Report Title:	Stage 2 Road Safety Audit Response Report – Coventry City Council, Clifford Bridge Road, Coventry Cycle Facilities
Date of Report:	September 2025
Document Ref & Revision:	SA5118
Prepared by:	Gill Wharton
On behalf of:	Waterman Aspen

Project:	Binley Cycleway – Clifford Bridge Road Section 7 (Phase 2)
Report Title:	Stage 2 Road Safety Audit Response Report
Prepared by:	
Name:	Louise Colley
Position:	Project Manager (Highway Delivery)
Signed:	
Organisation:	Coventry City Council
Date:	09/10/2025

GG119 Road Safety Audit Decision Log

Problem 7.1
Mill Lane – BCWY/0100/07

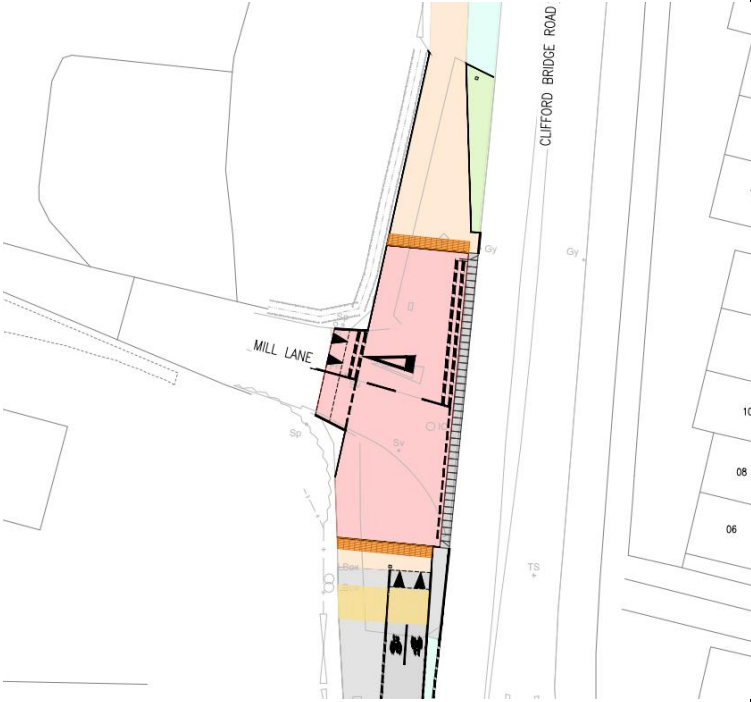
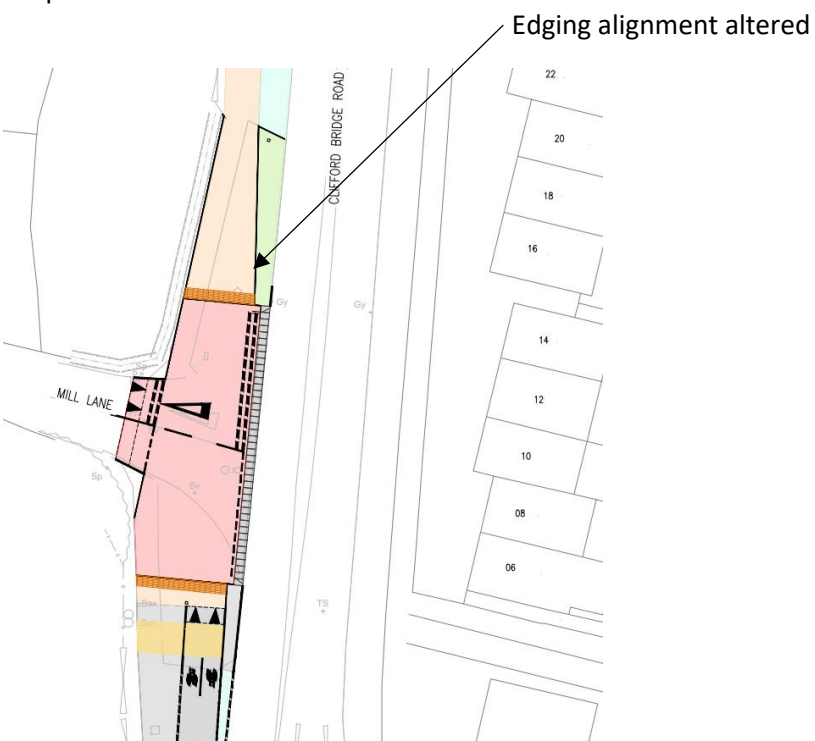
RSA PROBLEM	RSA Recommendation	Design Organisation Response (Choose one of for each response) 1) accept the RSA problem and recommendation made by the RSA team; 2) accept the RSA problem raised, but suggest an alternative solution, giving appropriate reasoning; or 3) disagree with the RSA problem and recommendation raised, giving appropriate reasoning for rejecting both.	Overseeing Organisation Response	Agreed RSA Action
<p>Problem 7.1 (Formerly Problems 7.7 in Nov'24 Stage 1 RSA) Risk of Cyclists Becoming Unseated Due to Proximity to Dutch Kerbs The drawings submitted for the audit show Dutch Kerbs being installed across the side junctions. These Dutch kerbs are proposed adjacent to the cycleways where cyclists will be travelling. The audit team are concerned that the close proximity of the gradient from the Dutch kerb to the path cyclists will be travelling will result in a risk of cyclists becoming unseated</p>	<p>Previous Recommendation - It is recommended that there should be space between the path that cyclists will be following and any level differences introduced by the Dutch Kerbs.</p> <p>Further Comment from Stage 2 RSA - The Audit Team acknowledge that this problem has partially been resolved through the latest design but is still outstanding and relevant to</p>	<p>Previous Design Organisation Response – Problem acknowledged. Cycle track will be offset and if possible, the extents of the Dutch Kerbs reduced.</p> <p>Stage 2 RSA Design Organisation Response – (1) ACCEPT, the edging kerb to be realigned and the verge area will be extended, to guide cyclists away from the Dutch kerb edging. Please refer to Appendix I - Problem 7.1.</p>	<p>Update the layout as required to resolve the problem raised.</p>	<p>Design is to be updated as required.</p>

Problem 7.3

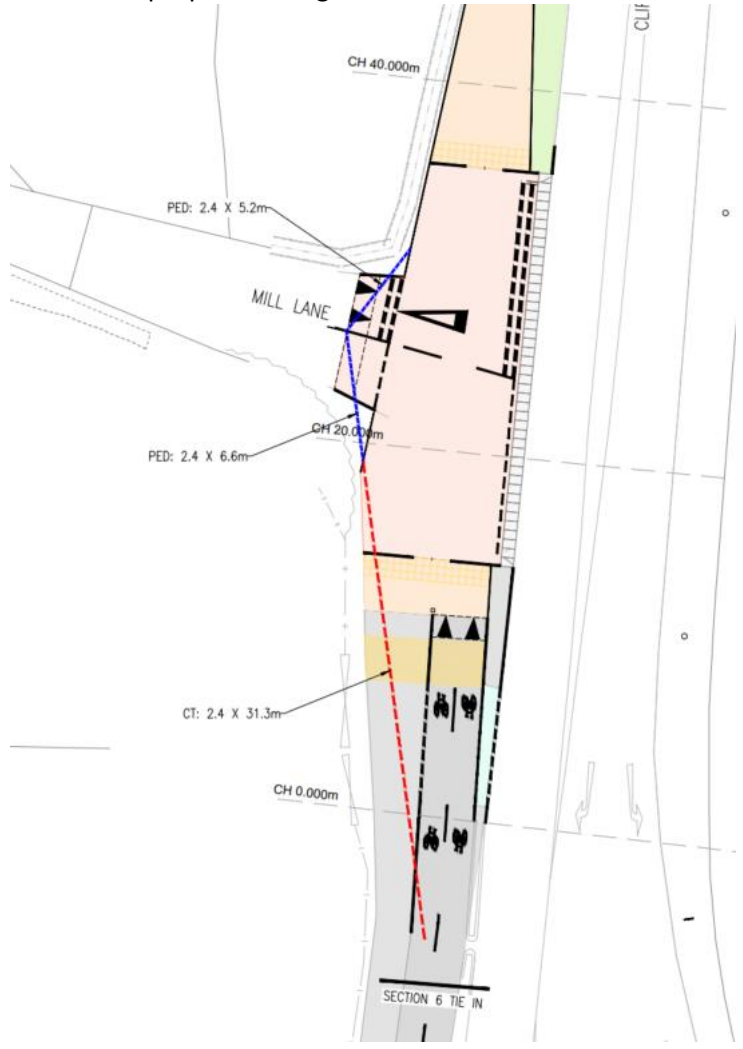
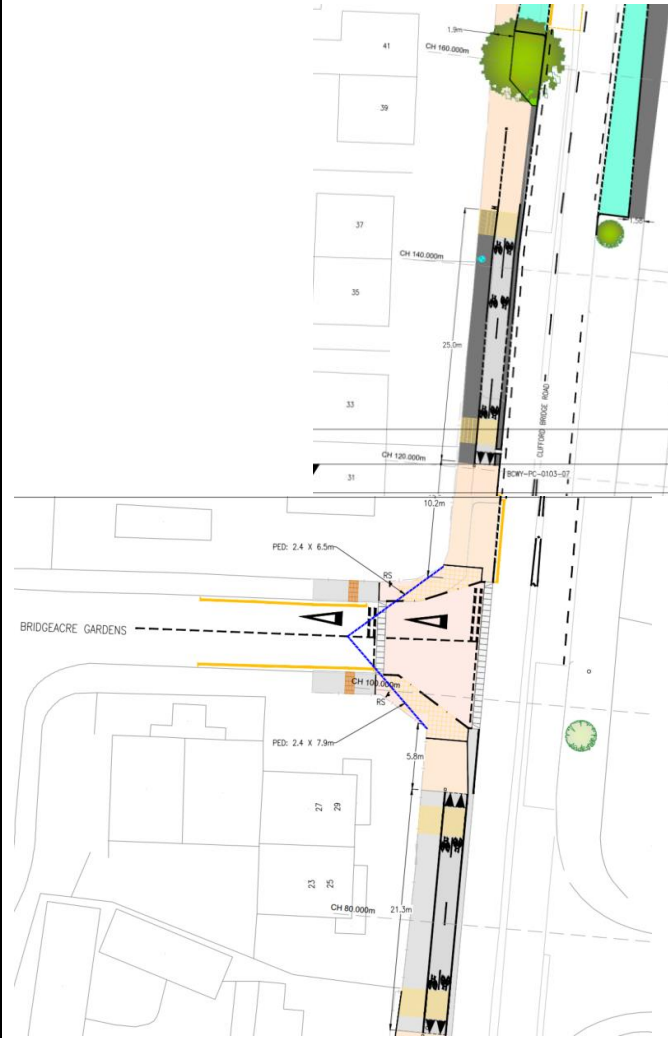
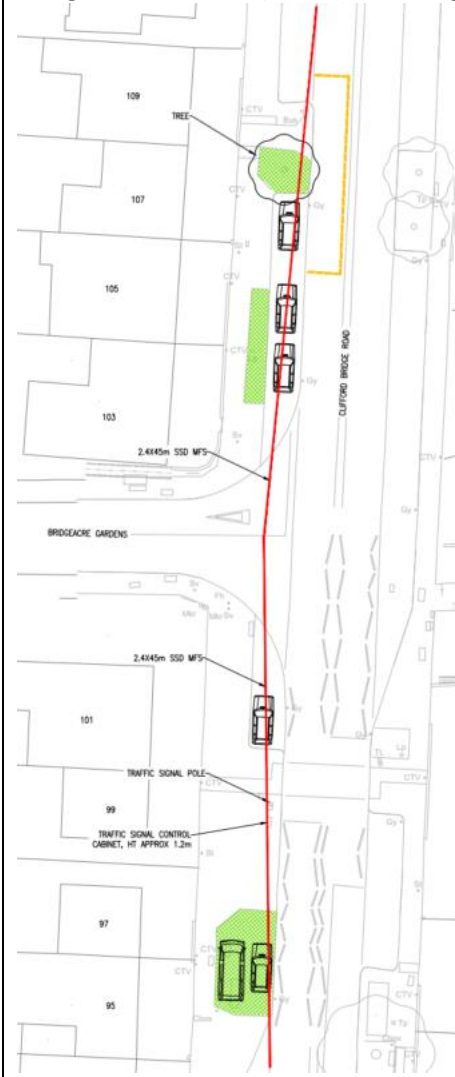
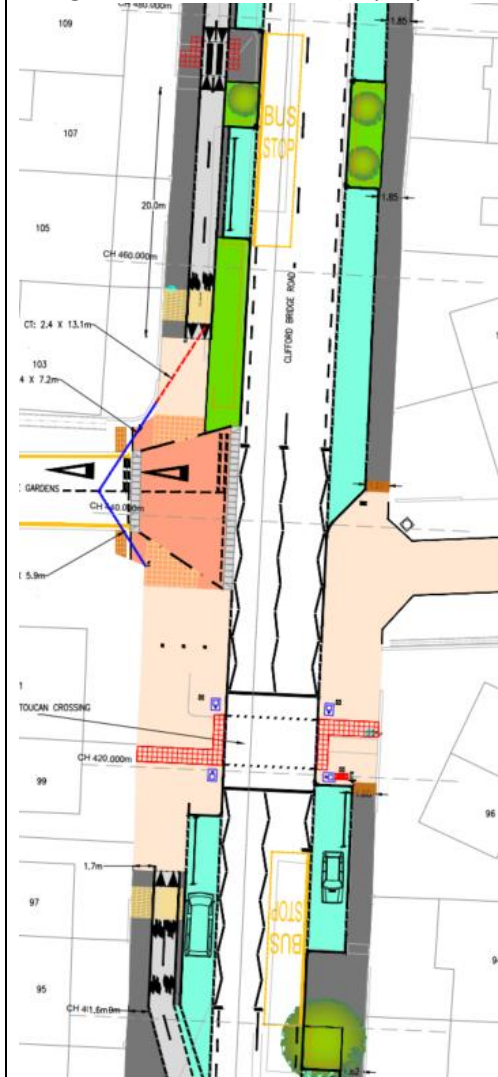
RSA PROBLEM	RSA Recommendation	Design Organisation Response (Choose one of for each response) 1) accept the RSA problem and recommendation made by the RSA team; 2) accept the RSA problem raised, but suggest an alternative solution, giving appropriate reasoning; or 3) disagree with the RSA problem and recommendation raised, giving appropriate reasoning for rejecting both.	Overseeing Organisation Response	Agreed RSA Action
problem is exacerbated by the absence of tactile paving leaving pedestrians unaware they are entering the carriageway as described in problem 7.10 above.		Stage 2 Design Organisation Response – (2) PARTIALLY ACCEPT, The existing situation is that cars passing through the proposed set back Give Way positions can do so without pausing/stopping and move on to the current Give Way markings. The proposed set back Give Way will make vehicles pause or stop before the crossing. The raised table of red macadam will indicate the potential for pedestrians or cyclists crossing the junction. The visibility splays from the proposed set back Give Way position, do not meet the criteria for Manual for Street 2 but are as existing. This proposed design may improve the existing situation. Please refer to Appendix I – Problem 7.3

Problem 7.4

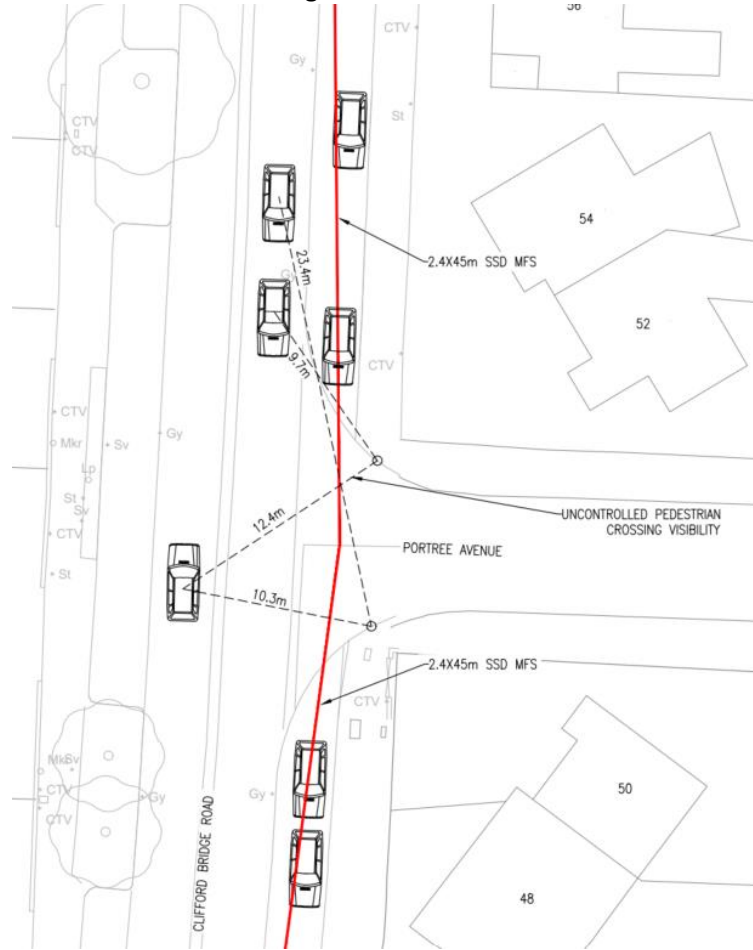
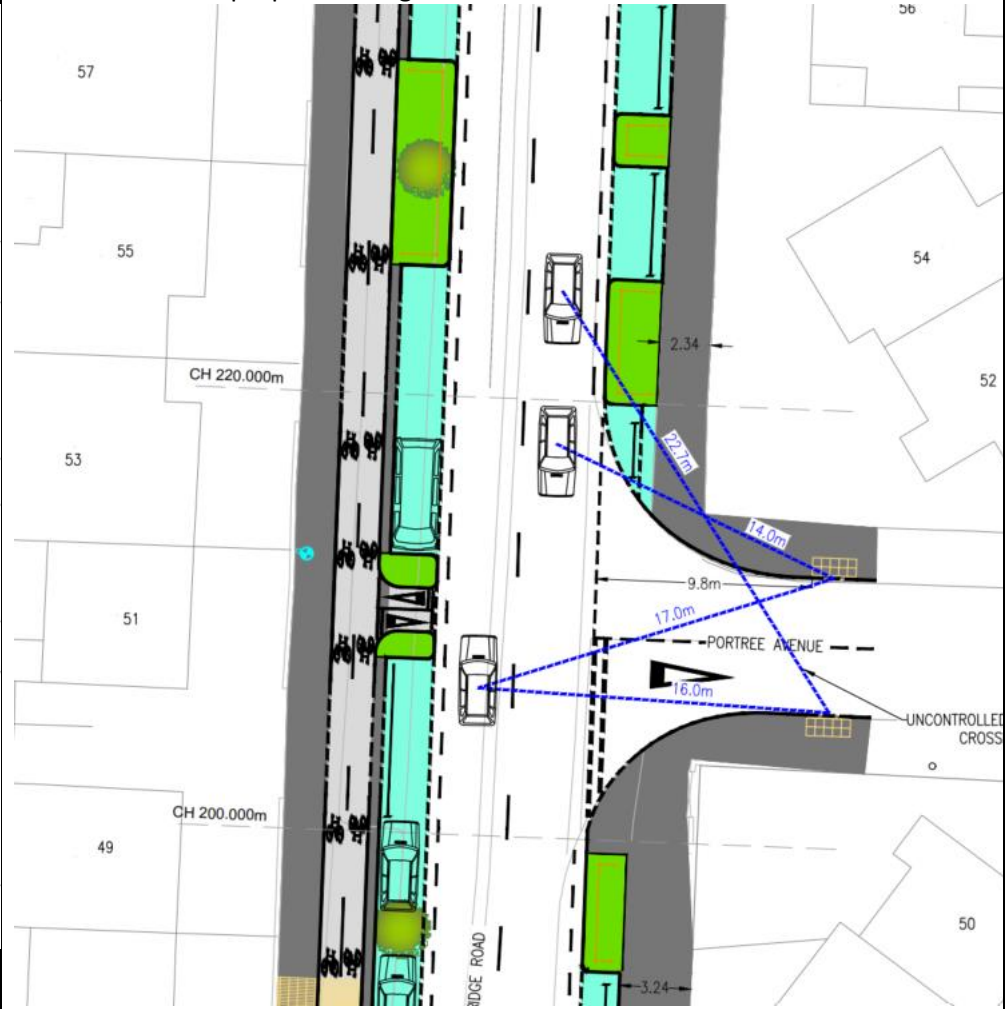
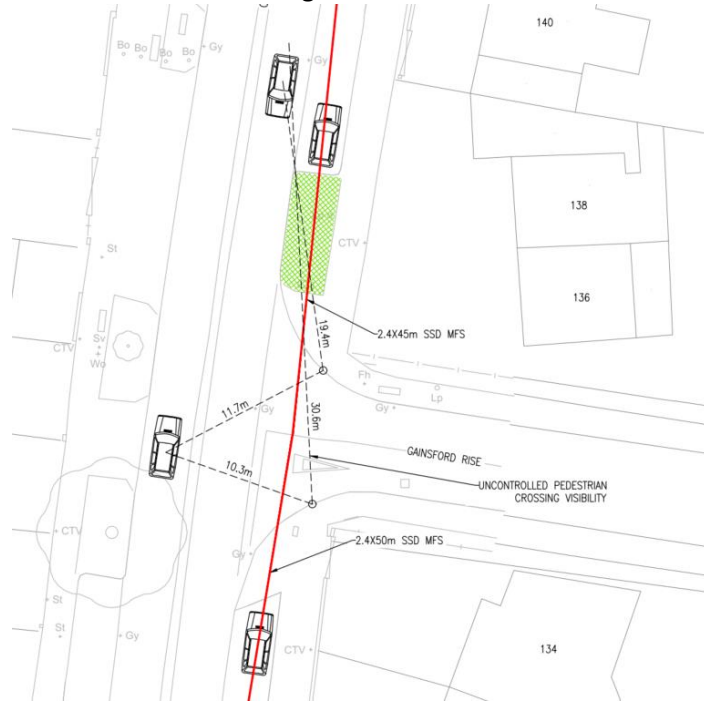
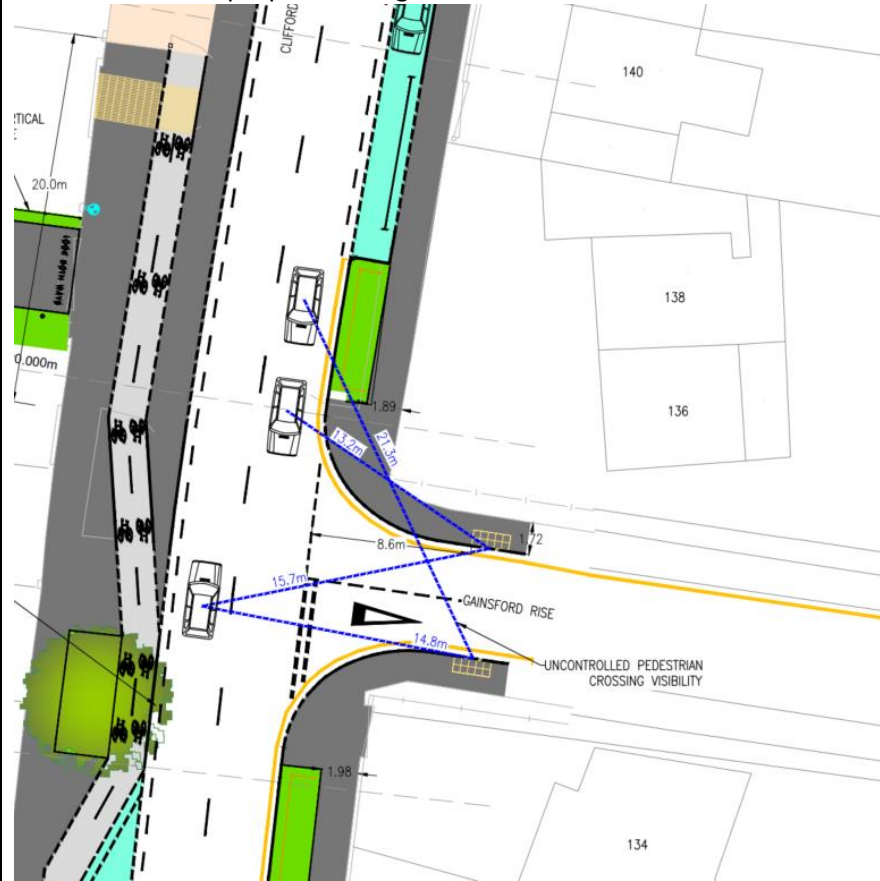
Problem 7.4 (formerly problem 7.14 in Nov'24 Stage 1 RSA) Risk of Pedestrian Collisions with Vehicles due to Locations of Uncontrolled Crossings	Previous Recommendation – It is recommended that adequate visibility splays should be provided for all crossings and that crossings should be provided on	Previous Design Organisation Response – Problem acknowledged. However, to accommodate the proposed cycle track and shared use facilities on the western side of Clifford Bridge Road the existing channel	The placement of the uncontrolled crossing is not strictly on the pedestrian desire line, however, this positioning is necessary to accommodate the	No further action required.

RSA PROBLEM	RSA Recommendation	Design Organisation Response (Choose one of for each response) 1) accept the RSA problem and recommendation made by the RSA team; 2) accept the RSA problem raised, but suggest an alternative solution, giving appropriate reasoning; or 3) disagree with the RSA problem and recommendation raised, giving appropriate reasoning for rejecting both.	Overseeing Organisation Response	Agreed RSA Action
		<p>proposed cycle track and shared use facilities on the western side of Clifford Bridge Road, the existing channel lines at these junctions would be moved towards the east. This would have the effect of reducing the distance between the desire line and vehicles turning into these side roads. The same can be said for the driveway accesses on either side of the junctions. If these crossings were positioned on the desire lines, there could be a risk of pedestrians standing at a crossing with a vehicle in front of them whilst another was accessing a driveway behind them.</p> <p>Positioning the uncontrolled crossings further into the side roads will increase distance between pedestrians and vehicles turning into the side roads. Visibility splays have been investigated, please refer to Appendix I – Problem 7.4.</p>

Mill Lane – BCWY/0100/07

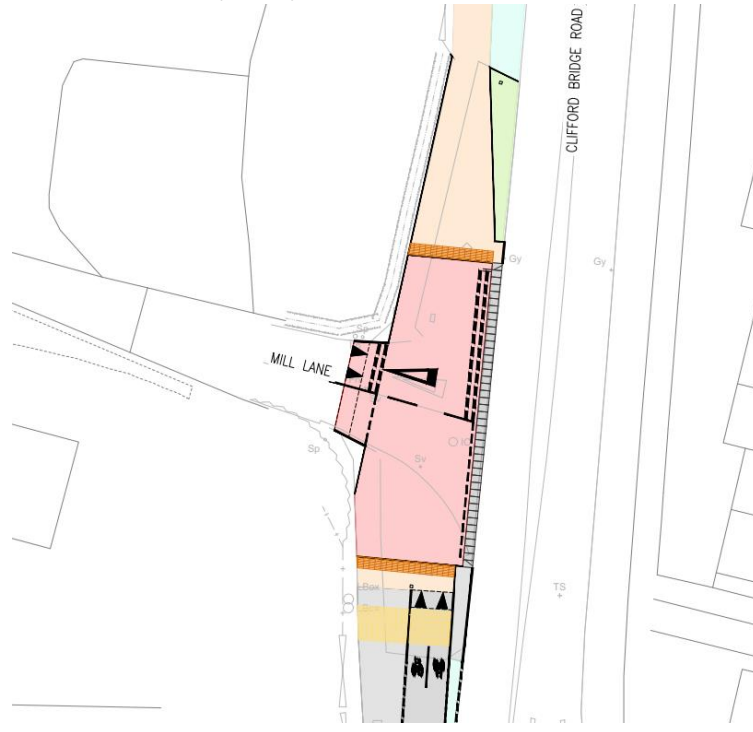
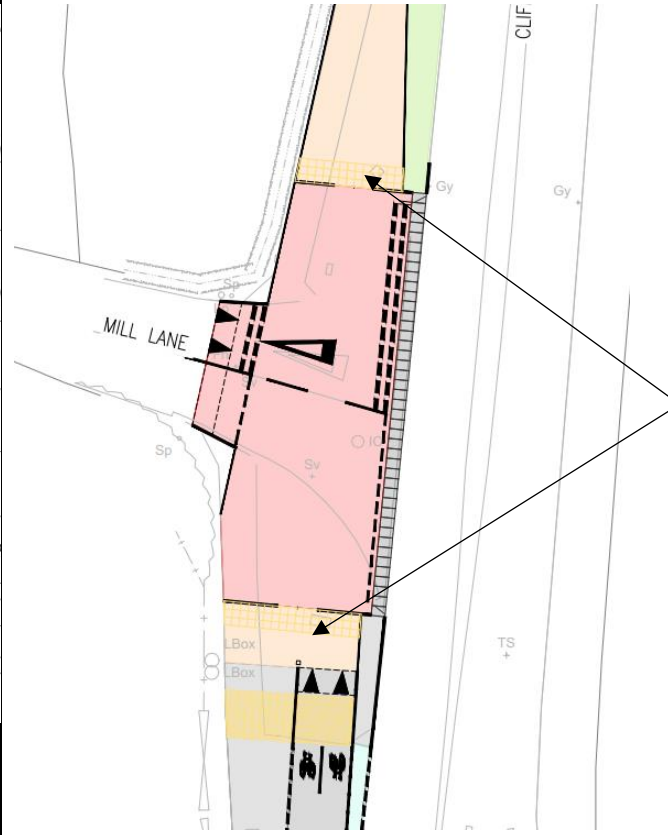
RSA PROBLEM	RSA Recommendation	Design Organisation Response (Choose one of for each response) 1) accept the RSA problem and recommendation made by the RSA team; 2) accept the RSA problem raised, but suggest an alternative solution, giving appropriate reasoning; or 3) disagree with the RSA problem and recommendation raised, giving appropriate reasoning for rejecting both.	Overseeing Organisation Response	Agreed RSA Action
collisions as a result of braking sharply at the last minute when they see a red signal.				
<p>Problem 7.6 Risk of pedestrian confusion and collisions with vehicles</p> <p>The drawings provided show the provision of hazard paving at the raised junctions for the side roads along Clifford Bridge Road for both pedestrians entering the junction from Clifford Bridge Road and from the side roads. Whilst hazard paving is correct on the side roads for pedestrians entering a shared space footway at this location, the Audit Team are concerned that using hazard paving to advise pedestrians that they are entering a live carriageway may cause confusion, increasing the risk of collisions with vehicles.</p>	<p>Stage 2 RSA Recommendation – It is recommended that hazard paving should be used to highlight the start/end of a shared space and blister tactile paving should be used at uncontrolled crossing locations throughout the scheme. It should be noted that pedestrians entering the raised table junctions from the side roads will enter the junction, carriageway side of the tactile paving for pedestrians entering the raised table from Clifford Bridge Road. This means that although the hazard paving is correct to enter a shared space, there is no blister tactile to aid</p>	<p>Stage 2 RSA Design Organisation Response – (1) ACCEPT, buff tactiles to be installed across the length of the carriageway/crossing at the junctions. Please refer to Appendix 1 – Problem 7.6</p>	Update the layout as required to resolve the problem raised.	Design is to be updated as required.

Tactiles
changed
to buff
blisters
